**SUSQUEHANNA STEAM ELECTRIC STATION
REVISION TO PLA – 5341
PROPOSED AMENDMENT NO. 240 TO LICENSE
NFP-14 AND PROPOSED AMENDMENT NO. 205 TO
LICENSE NFP-22: CHANGES TO REACTOR PRESSURE VESSEL
PRESSURE-TEMPERATURE (P-T) LIMITS AND REQUEST FOR
EXEMPTION FROM THE REQUIREMENTS
OF 10CFR50 SECTION 50.60(a).
PLA-5345**

**SUSQUEHANNA STEAM ELECTRIC STATION
PROPOSED AMENDMENT NO. 240 TO LICENSE
NFP-14 AND PROPOSED AMENDMENT NO. 205 TO
LICENSE NFP-22: CHANGES TO REACTOR PRESSURE VESSEL
PRESSURE-TEMPERATURE (P-T) LIMITS AND REQUEST FOR
EXEMPTION FROM THE REQUIREMENTS
OF 10CFR50 SECTION 50.60(a)
PLA-5341**

The purpose of this letter is to propose revisions to the Susquehanna Steam Electric Station Units 1 and 2 Technical Specifications Figure 3.4.10-1 "Reactor Vessel Pressure vs. Minimum Vessel Temperature", and the associated TS Surveillance Requirements SR 3.4.10.1 and 3.4.10.2. In addition, changes are also made to TS Bases B3.4.10 and B3.10.1.

Figure 3.4.10-1 (page 1 of 1)

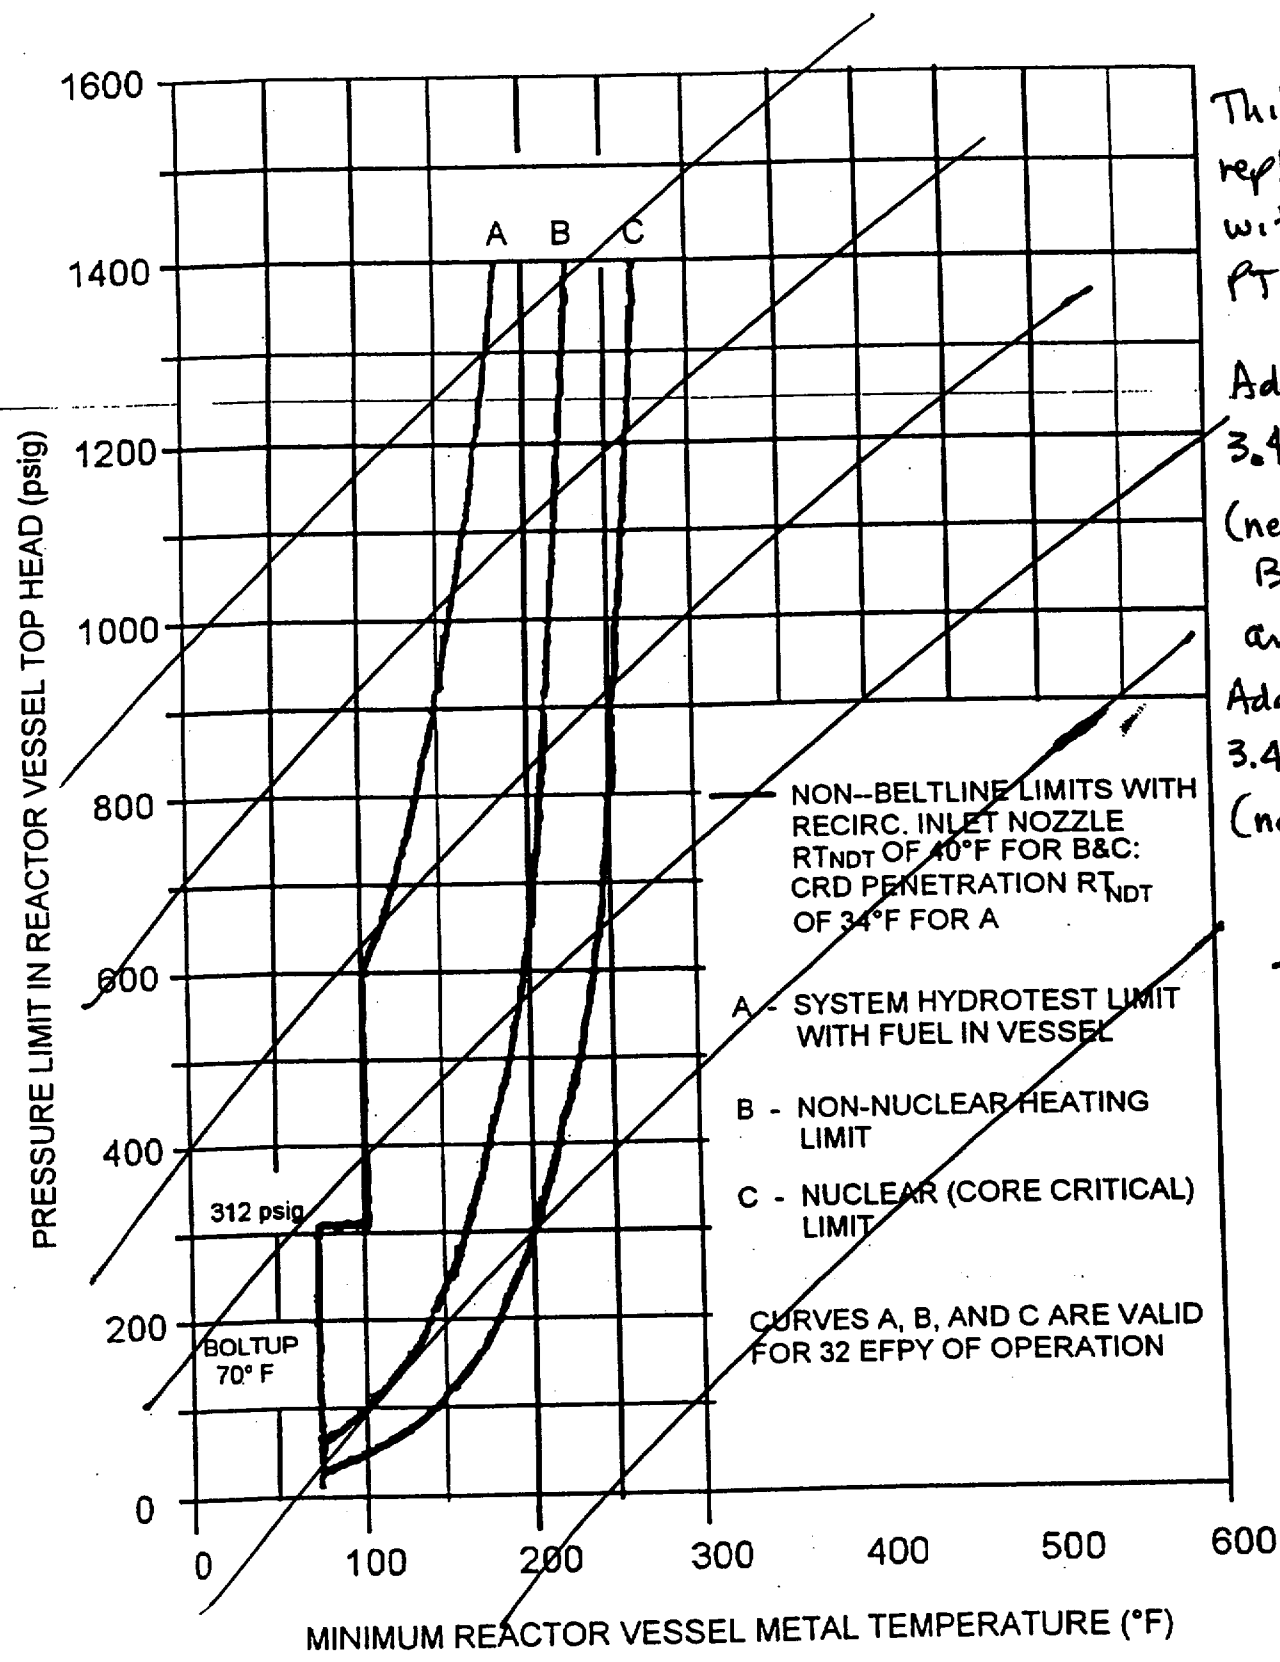
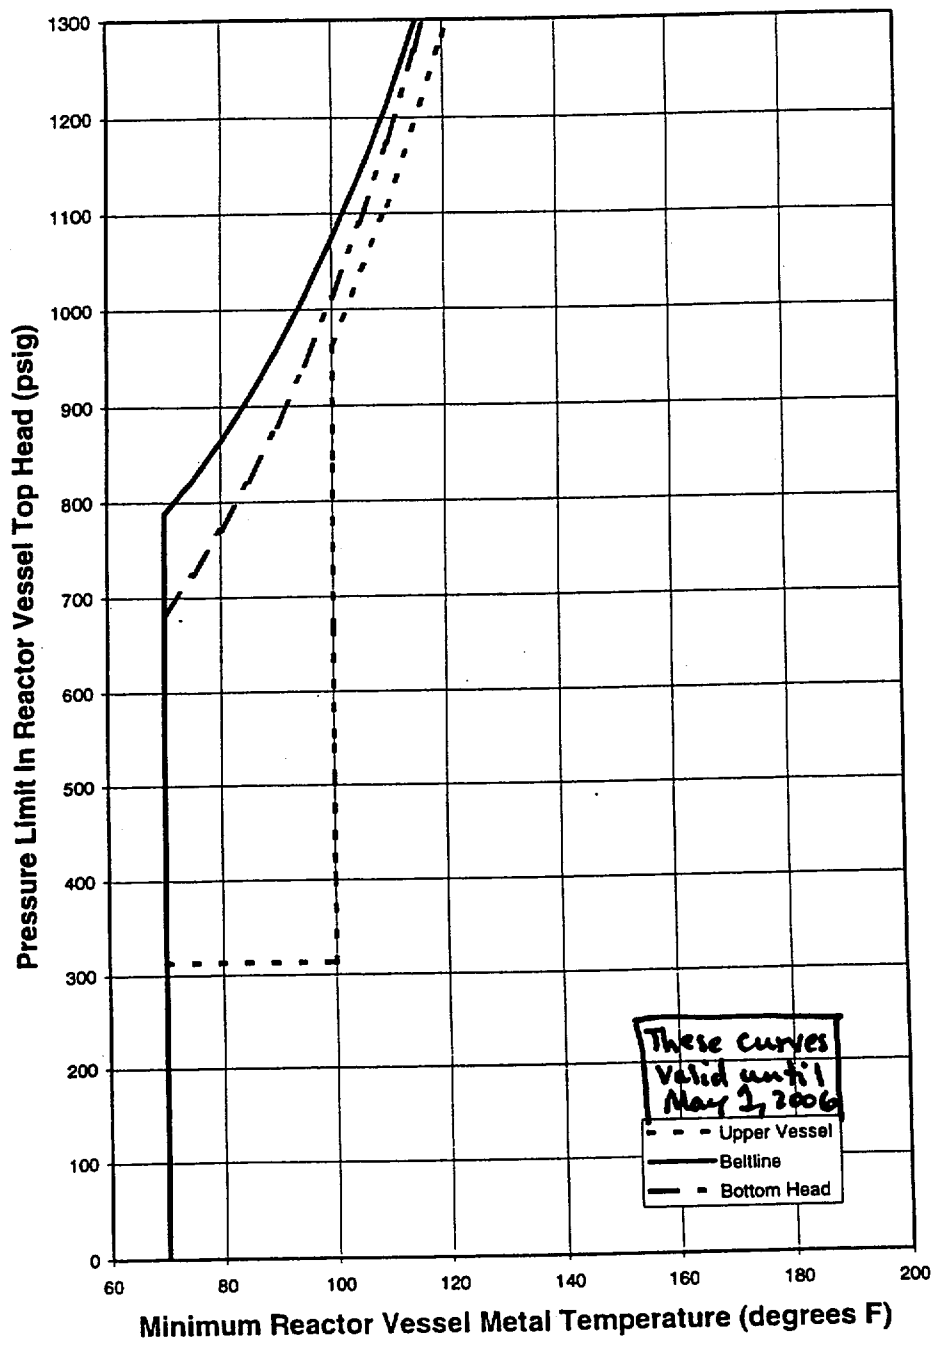
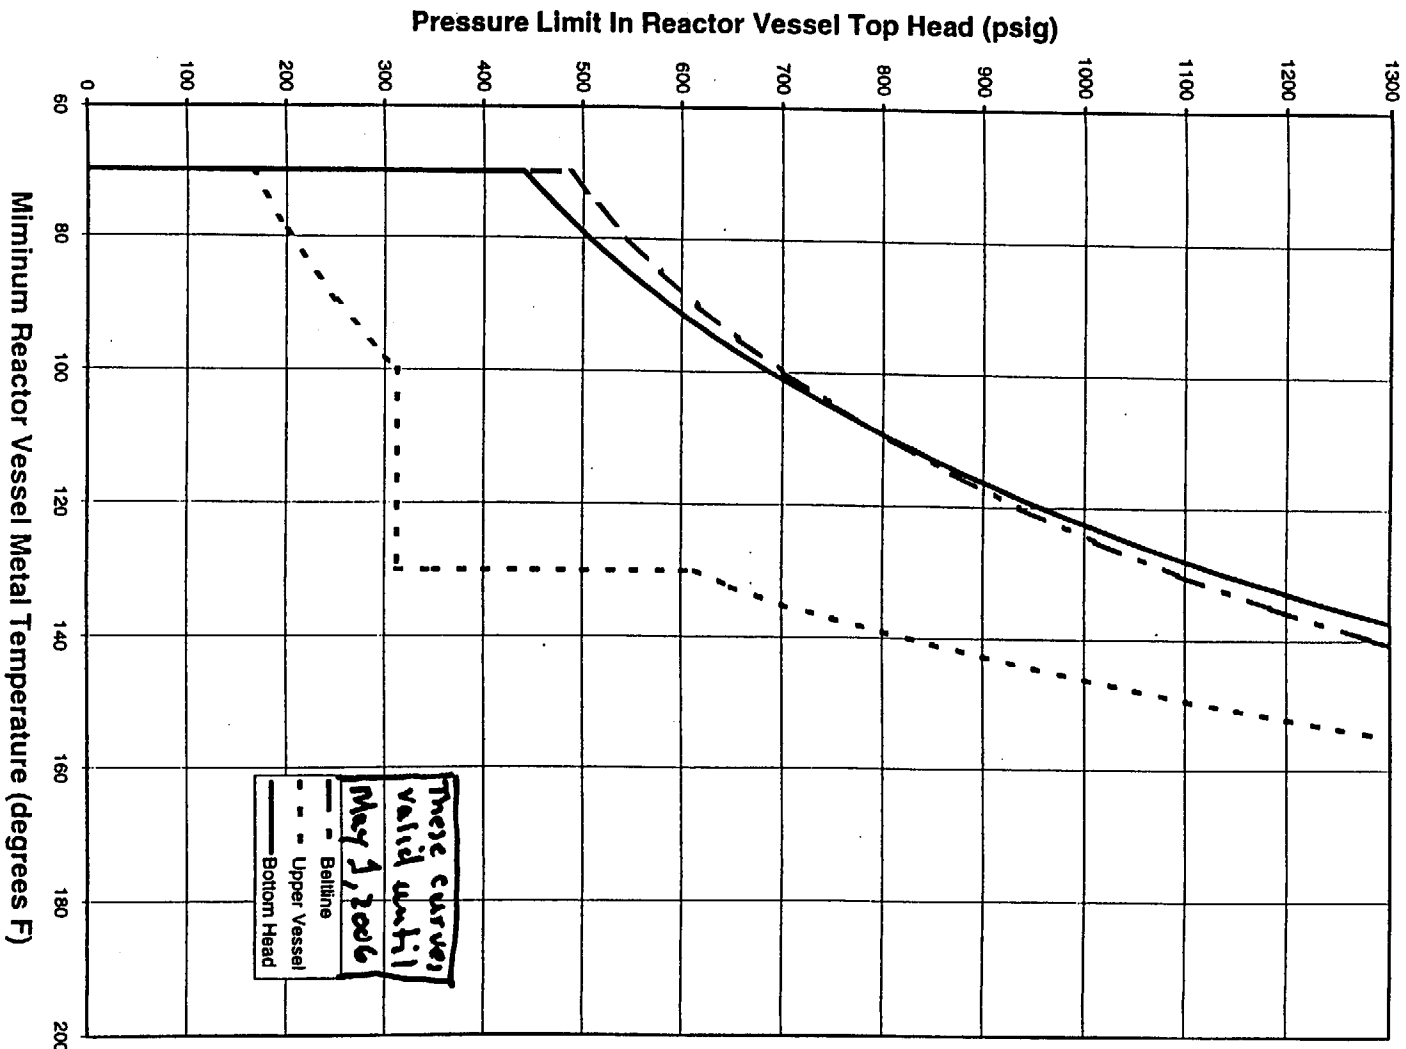
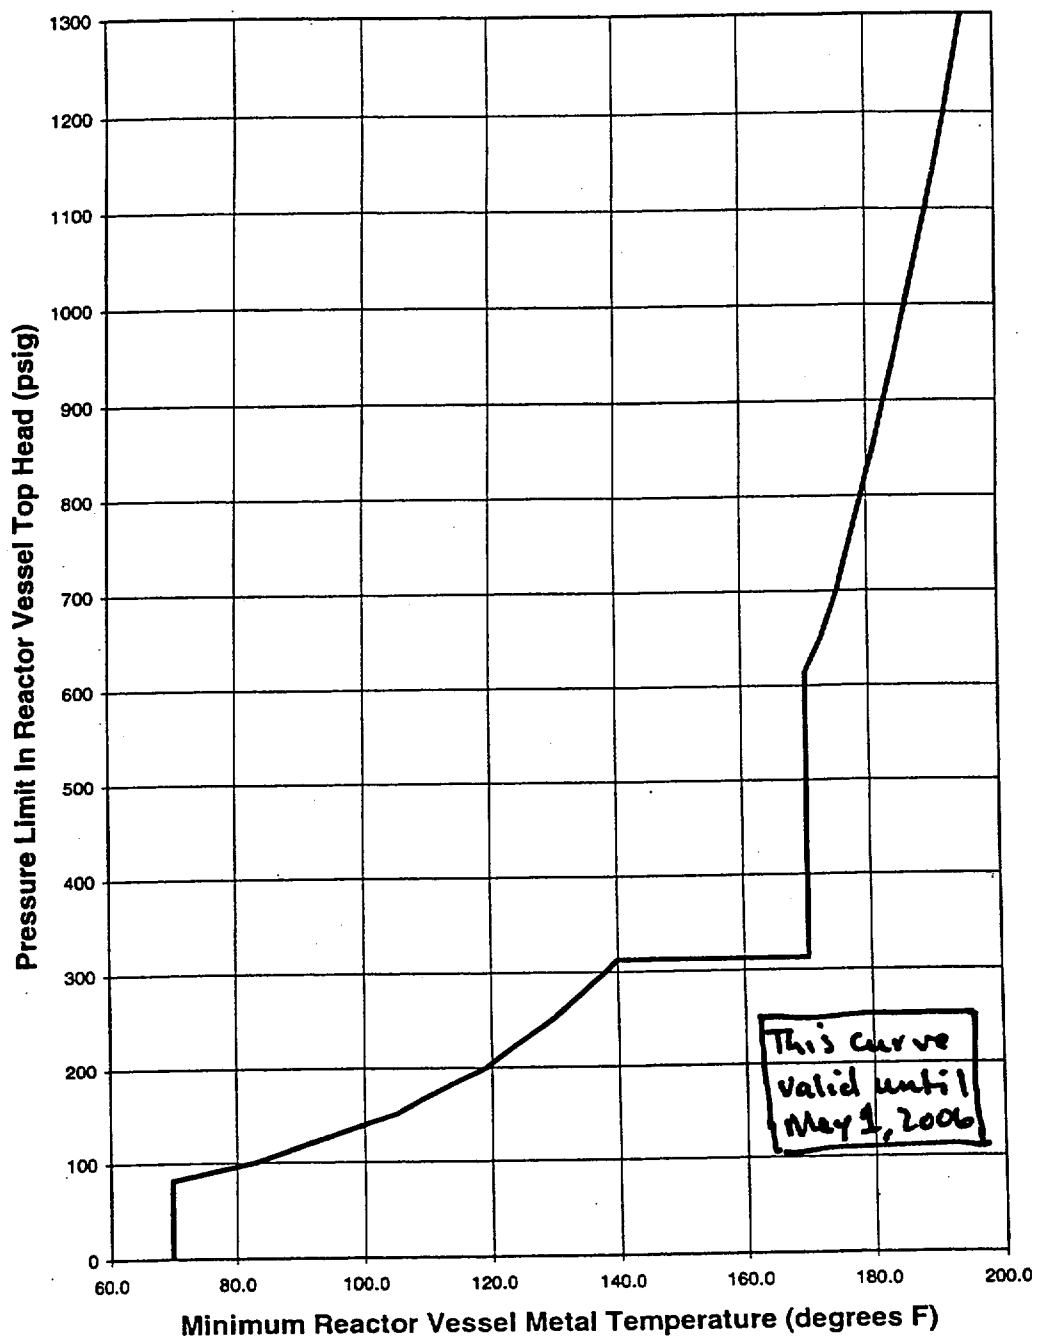
This figure replaced with new PT Curve A, Add Figure 3.4.10-2 (new Curve B) and Add Figure 3.4.10-3 (new Curve C)

~~Figure 1~~ **Figure 3.4.10-1**
 Pressure Test P-T Curve (Curve A) for ~~Unit 1~~

~~Figure 3.4.10-2~~ Figure 3.4.10-2
Core Not Critical Curve (Curve B) for Unit 1

~~Figure 5~~ Figure 3.4.10-3
Core Critical Curve (Curve C) for Unit 1

The proposed changes are to the Units 1 and 2 Technical Specification Figure 3.4.10-1, which shows the P-T limit curves for inservice leakage and hydrostatic testing, non-nuclear heatup and cooldown, and criticality, respectively.

The number of curves has been expanded from one to three to separately address beltline, bottom head, and non-beltline regions. In addition to the curve changes, editorial changes to the Limiting Condition for Operation and Surveillance Requirements of Technical Specification 3.4.10 are also proposed.
